HITACHI SEMICONDUCTOR TECHNICAL UPDATE

Classification of Production	Microprocessor		No	TN-SH7-447A/E	Rev	1
THEME	Usage notices of the SH7709S/SH7729R/SH7709A/SH7729 MCS0	Classification of Information	1. Spec change 2. Supplement of Documents ③ 3. Limitation of Use 4. Change of Mask 5. Change of Production Line			
PRODUCT NAME	HD6417709S	Lot No.	Reference Documents	SH7709S Hardware manual Rev.3.0 ADE-602-250B SH7729R Hardware manual Rev.3.0 ADE-602-229B SH7709A Hardware manual Rev.5.0 ADE-602-187D SH7729 Hardware manual Rev.4.0 ADE-602-157C		Effective Date
	HD6417729R	ALL				Eternity
HD6417709A						
HD6417729

fig. 1. The case accessing area 2

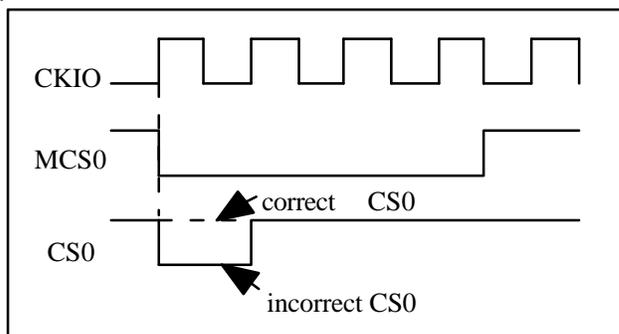
- The case accessing area 2 : CS0 is incorrectly asserted during the first CKIO cycle of MCS0 access cycle.

- Don't use MCS0
- When using MCS0, please set CS2/0 bit in MCSCR0 "0".

fig. 2. The case accessing area 0

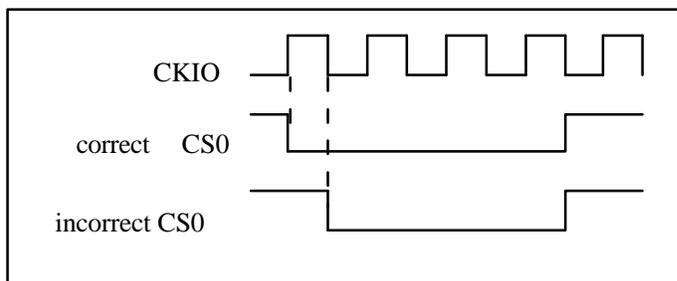
- The case accessing area 0 : CS0 is asserted half CKIO cycle later than the correct timing.
